The City of Lake Elmo  
Planning Commission will conduct a meeting on  
**Monday February 25, 2019**  
**at 7:00 p.m.**  
**AGENDA**

1. Pledge of Allegiance
2. Approve Agenda
3. Approve Minutes
  - a. February 11, 2019
4. Public Hearings
  - a. **PRELIMINARY PLAT, EASEMENT VACATIONS AND REZONING.** Pulte Homes of Minnesota is requesting City approval of preliminary plat, easement vacations, and a rezoning to develop a townhouse project called "Bentley Village". This development would be on the south side of 5<sup>th</sup> Street across from Jasmine Road and Junco Road in Section 34, Township 29, Range 21 and would have 240 attached townhomes on about a 41.6 acre site for an average density of 5.77 units per acre.

**City of Lake Elmo  
Planning Commission Meeting  
Minutes of February 11, 2019**

TYPICAL TOWNHOME LOT DETAIL

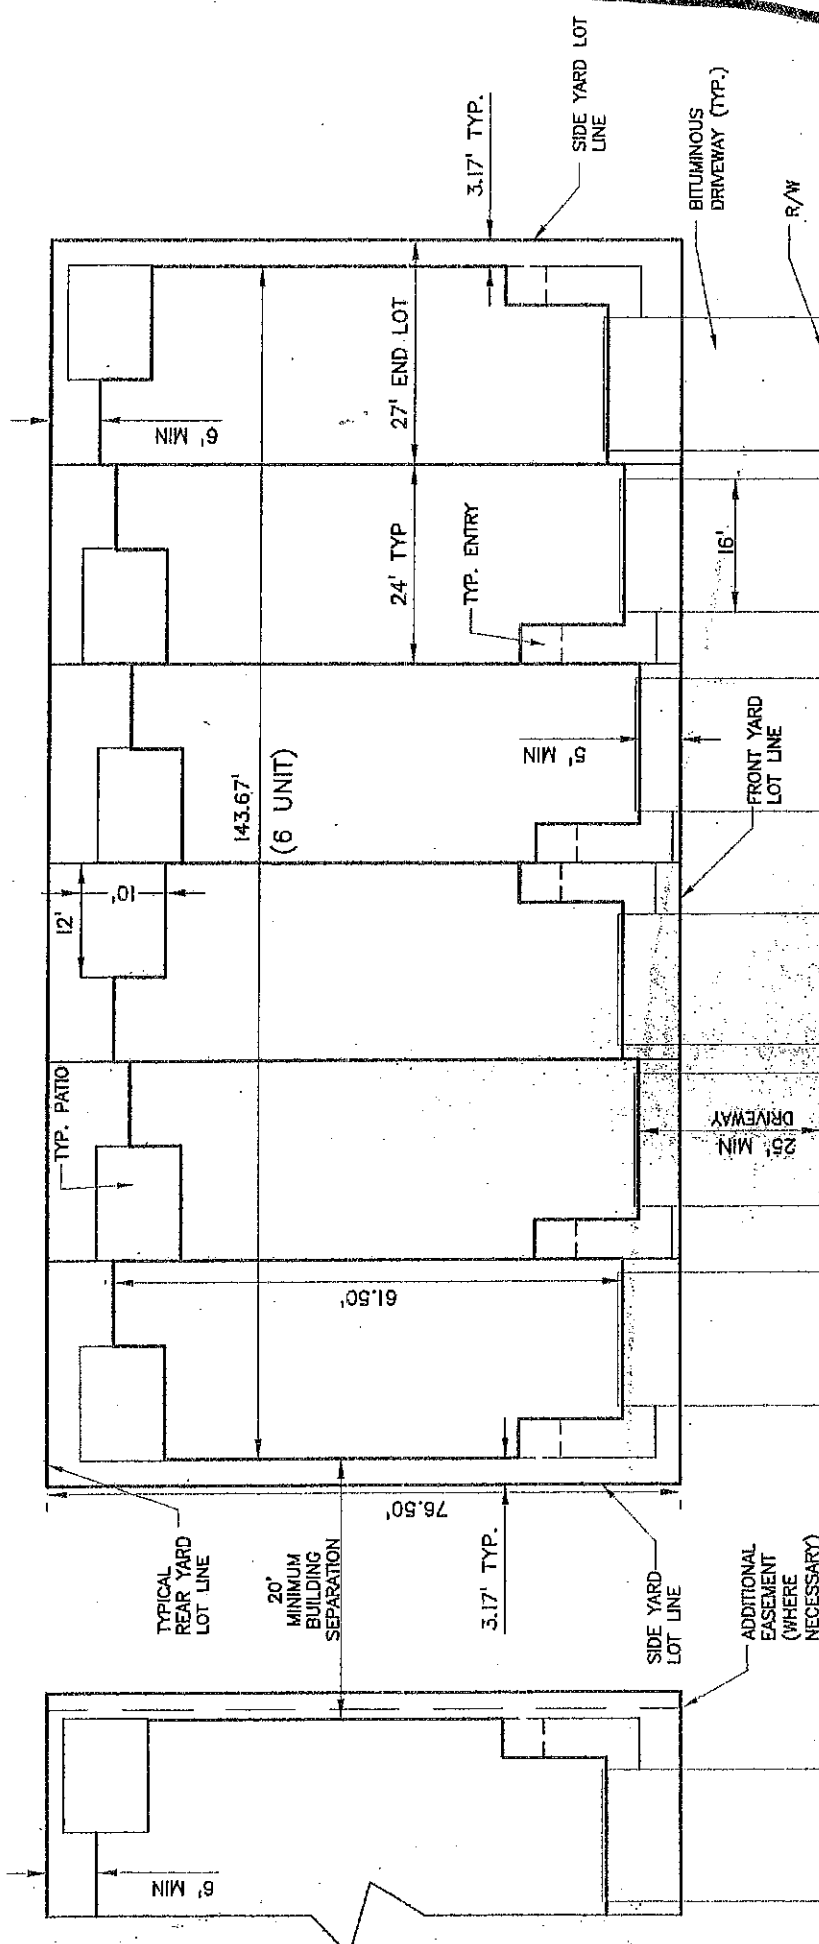
The project plans are not clear in showing that all of the proposed buildings and lots would meet all the required setbacks. Staff has included a detail from Sheet 7 of the project plans that has a typical townhome lot layout showing the proposed lot lines and the building placement. However, staff has identified several locations where it appears that corners of the proposed townhouses (or their patios) might encroach into required setbacks and/or easements or would be too close together to meet the City's 30-foot-spacing requirement to accommodate underground utilities (including storm sewer). These include:

Staff is recommending the developer revise the project plans to clearly show that all the units will meet all setback requirements and all spacing requirements for underground utilities.
